HISTORIC DISTRICT REVIEW BOARD WORK SESSION AGENDA

Agenda Item: APPLICATION FOR AN ADDITION, HDRB #24-005, to consider an application for a Certificate of Appropriateness for the addition of a front porch to the house located at 811 Elden Street.

Prepared by: Bryce Perry, Deputy Director of Community Development

④ Proposed Roof Plan
1/4" = 1'-0"

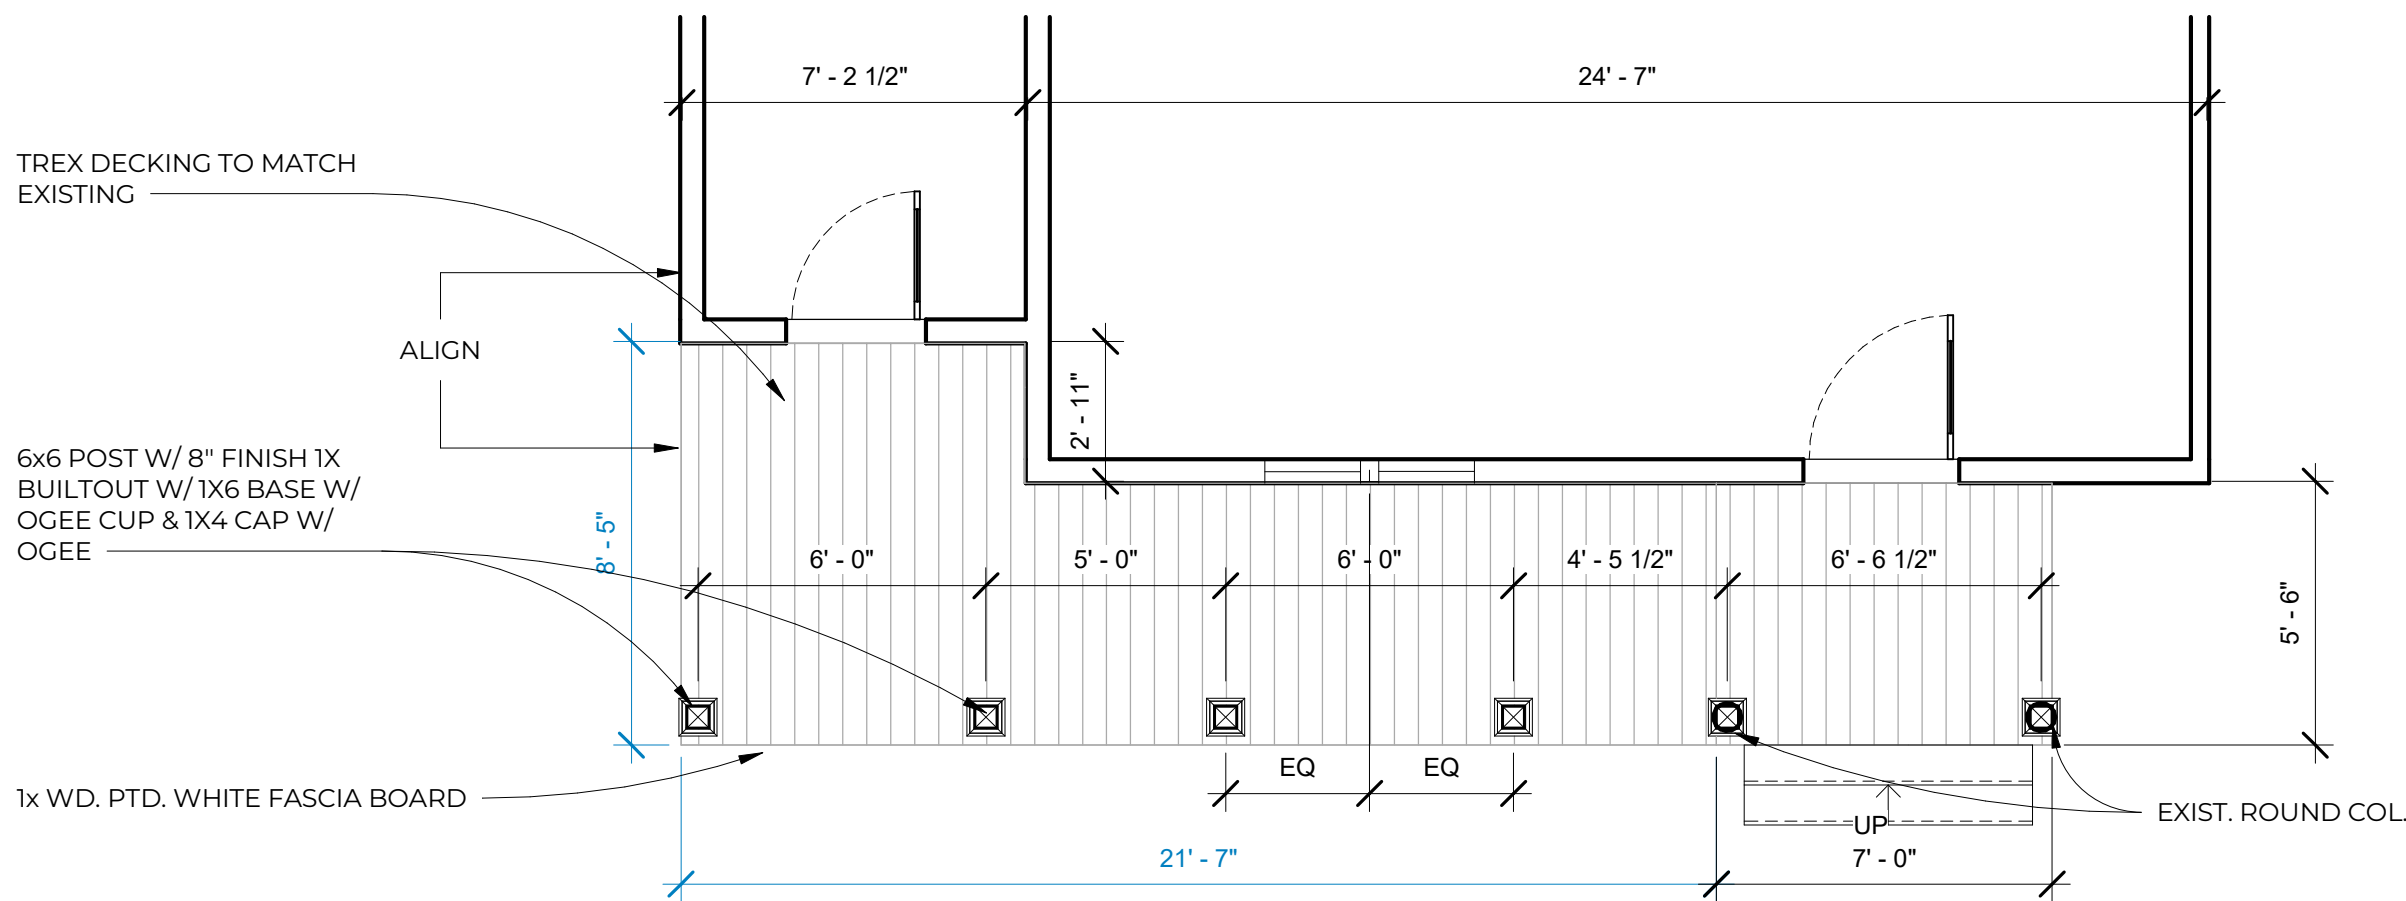
- Clarity is needed for how the roof ties in with the existing portico roof. The drawings show a valley that would collect rainwater.

- The slope of the roof seems very low. Low to the point whereby standing seam might not be able to be used. Using standing seam for the porch is a great option to match the material on the principal roof of the house, as a traditional material for a house of this age, and as a common historic building material used in the Herndon Historic District. However, at this slope, it is only very minimally visible. The slope should be increased to enhance the visibility and prominence of the porch's metal roof.

5 Proposed Front Elevation
1/4" = 1'-0"

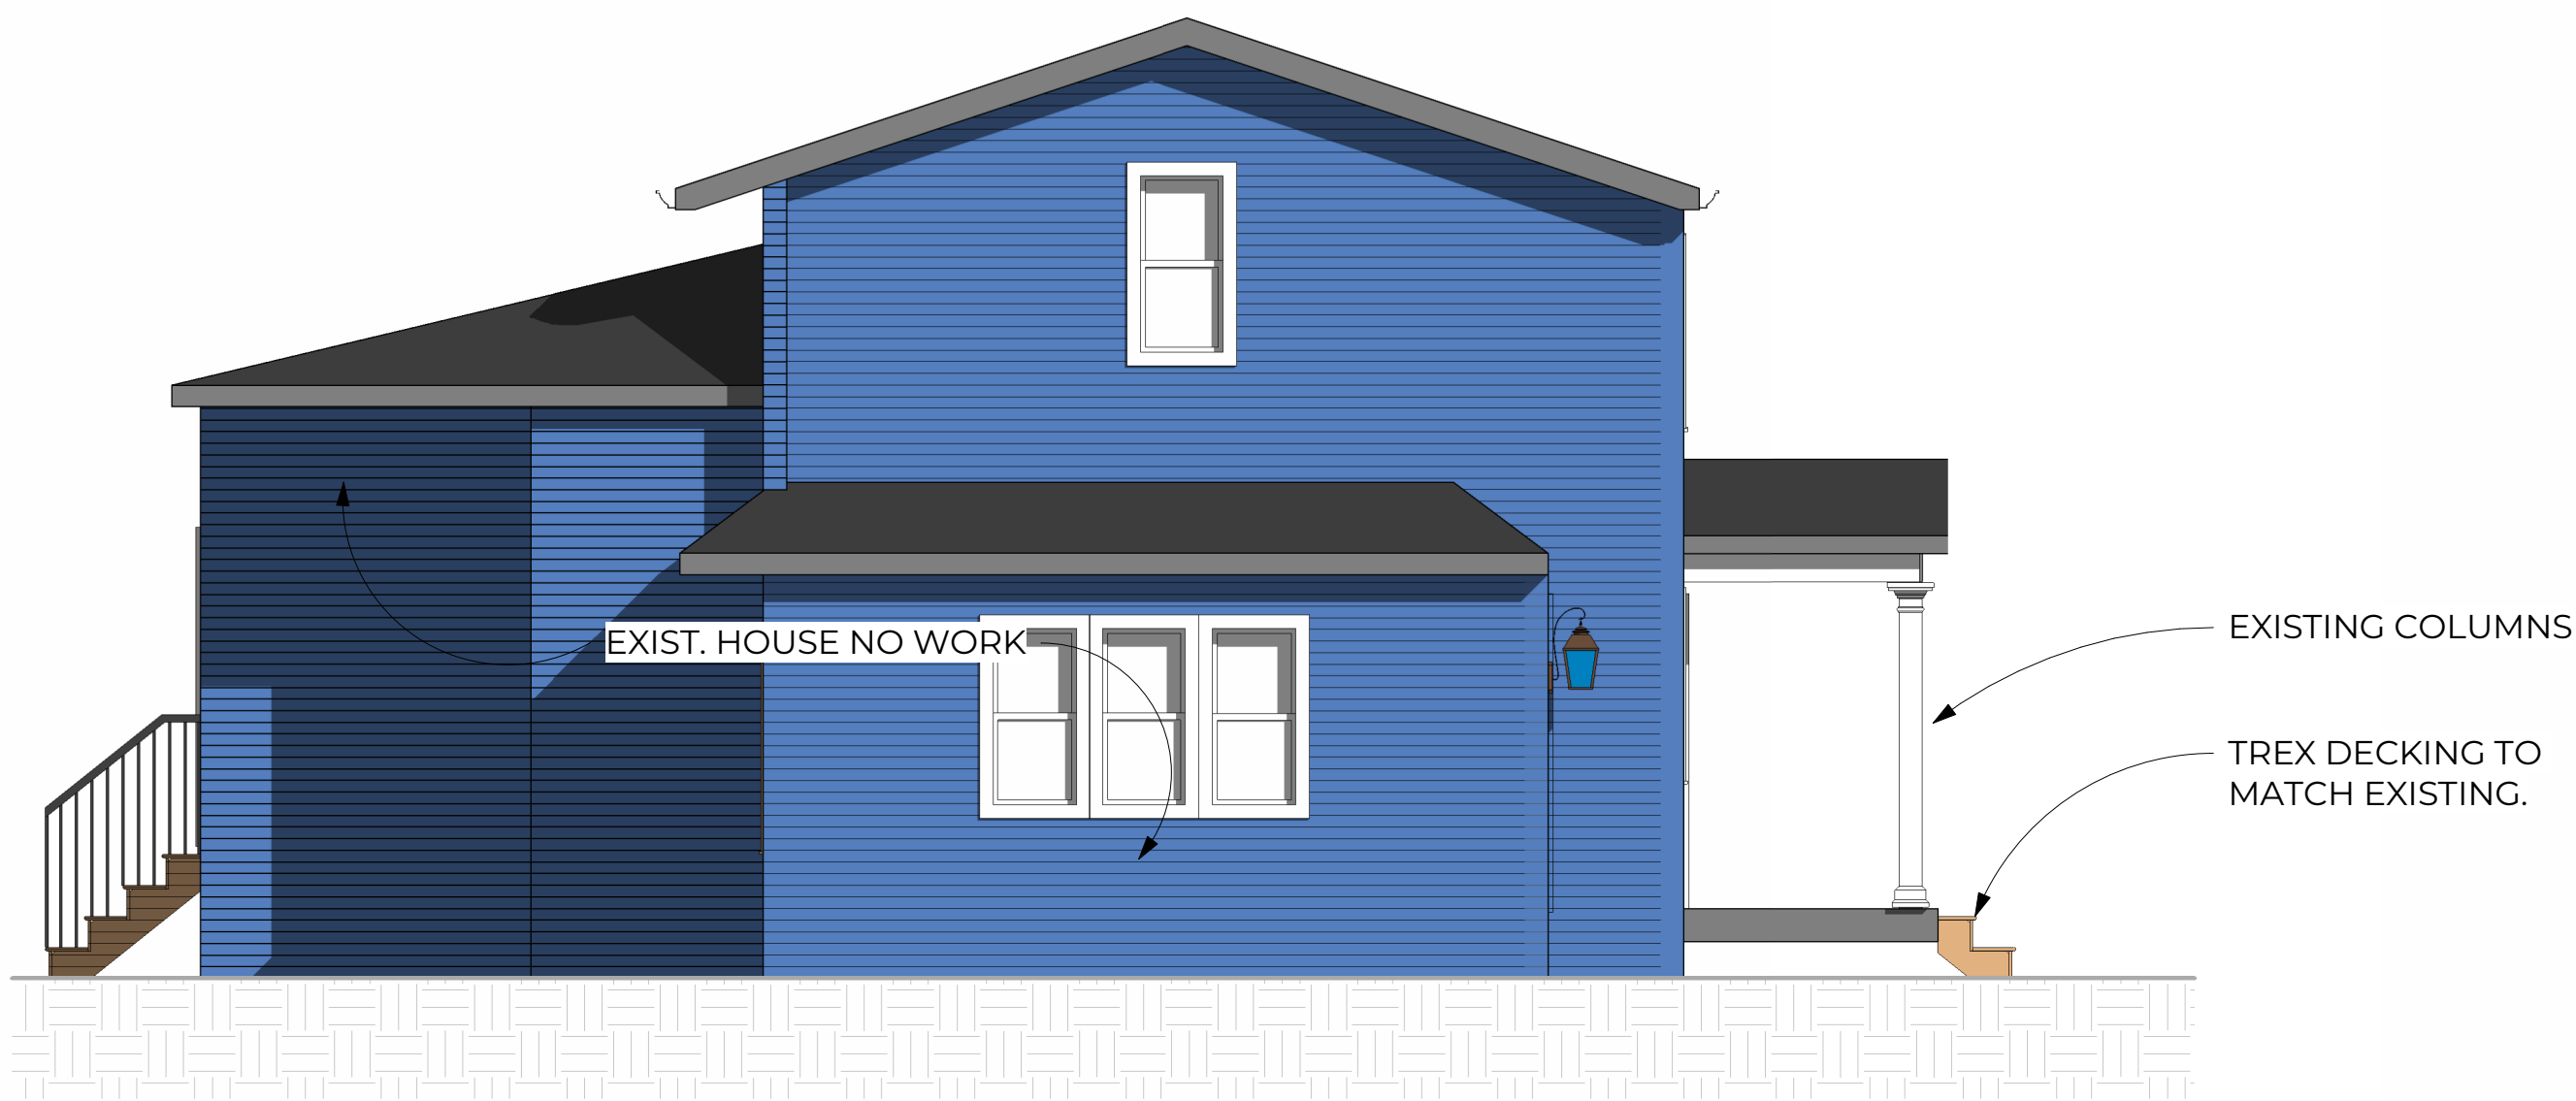
- The following information is unclear: the height of the porch, the appearance from the left elevation (the proposed porch is mistakenly not shown), the material of the piers, whether any skirt would be used between the piers, specifically what composite boards would be used (finish, size), how those boards would be oriented, and what joinery (open, tongue and groove) would be used, would there be any gutters and downspouts and if yes, what are the size, shape, style, color, location.
- Almost every porch column is spaced differently, creating an irregularity in the pattern

that, while quirky, looks like a mistake. In elevation view, it's clear the intent is to have the columns spatially relate to the windows and doors, however, the porch sticks out from the house and will be viewed almost always at an angle. From this perspective, more visual emphasis would be placed on the rhythm of the columns with little recognition of how that rhythm relates to the openings in the house.
